Front Seat Shield Is Loose or Separated - Power Seat Only

Service Category Vehicle Interior

Section Seat

Figure 2. Location of Separation

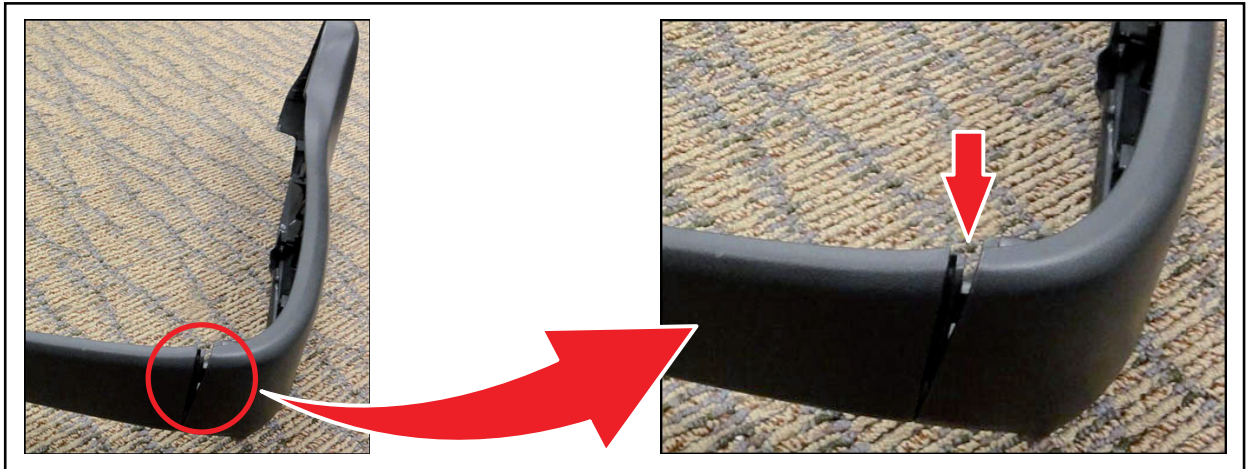
Some 2011 – 2013 model year Sienna vehicles may exhibit a condition where the outside seat shield is loose and separating, or has an excessive gap to the seat cushion or forward facing seat shield. The condition may occur on either the driver or passenger front power equipped seats. Follow the Repair Procedure in this bulletin to address this condition.

1. Confirm the vehicle exhibits the loose/separating or gap condition described in the Introduction.

2. Remove and replace the Inner No. 1 Front Seat Cushion Shield.
